SUBJECT: CamLite Corporation - FCC ID: QIH-CL1

REFERENCE: JOB 973UC3

In reply to your recent questions:

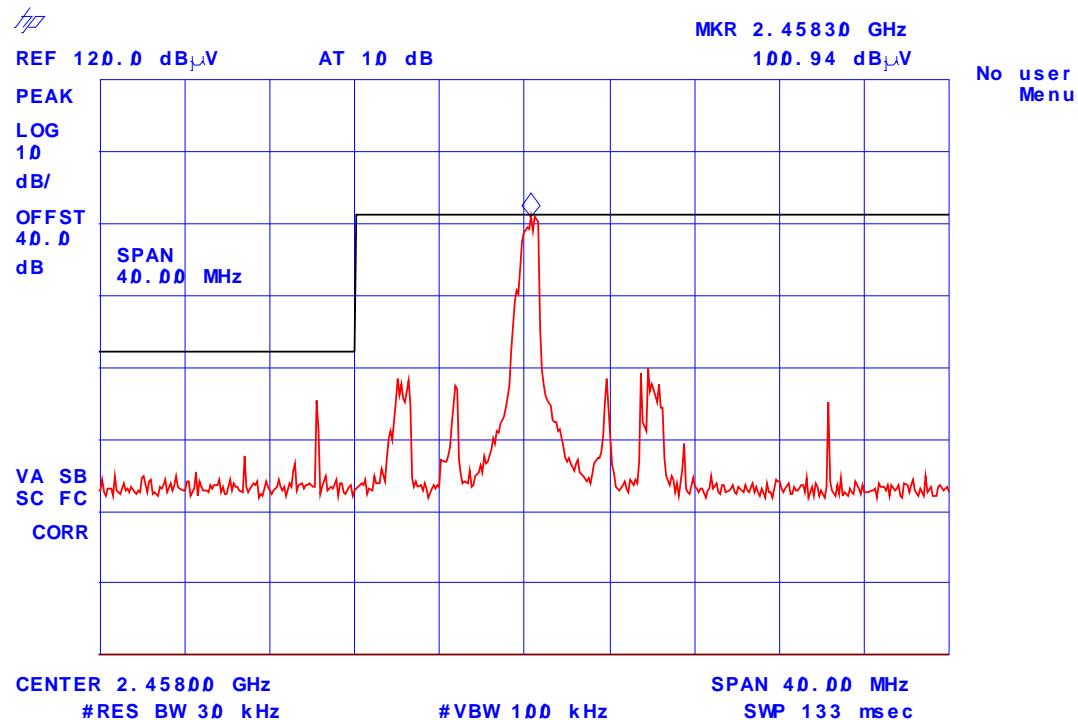
5. Necessary Bandwidth calculation (Nb): Please, use the Carson's rules ($2M+2D$) to determine the necessary bandwidth Nb. The 99% occupied bandwidth, as measured in the test report, is not the minimum bandwidth required to convey the information, as 1M32 includes only a portion of the modulated envelop. The color sub-carriers and sound carriers are missing. The data obtained in 5. should be used to calculate Nb.

Answer: There is no formula for FM, NTSC video with aural sub-carrier. Therefore, the measured 99% occupied band was used as the emission bandwidth.

Configuration: Frequency: 2458 MHz, Temperature: 20°C

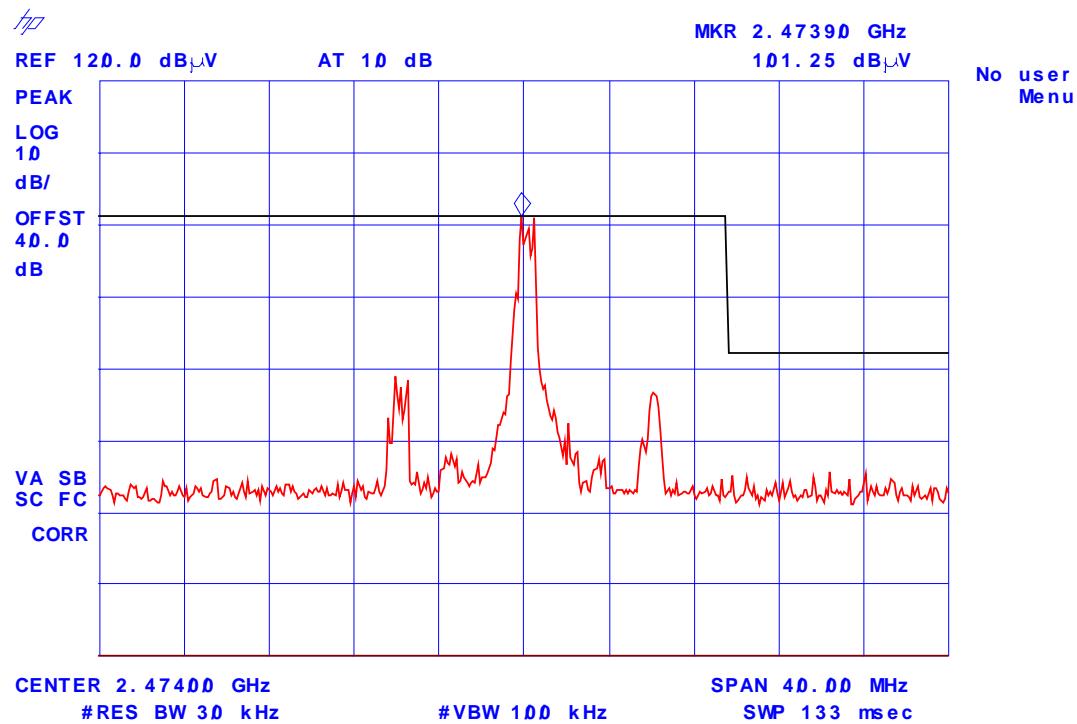
7. Frequency Stability as a function of Temperature and Voltage: Please, provide the actual measured frequency tolerance, which is required to be reported on 731 form. Additionally, please provide the tolerance at the battery end-point as required under part 2.1055(d)(2).

Answer: See revised 731 Form for measured frequency tolerance. Below are the data plots for frequency stability measured at battery end point (4 V):
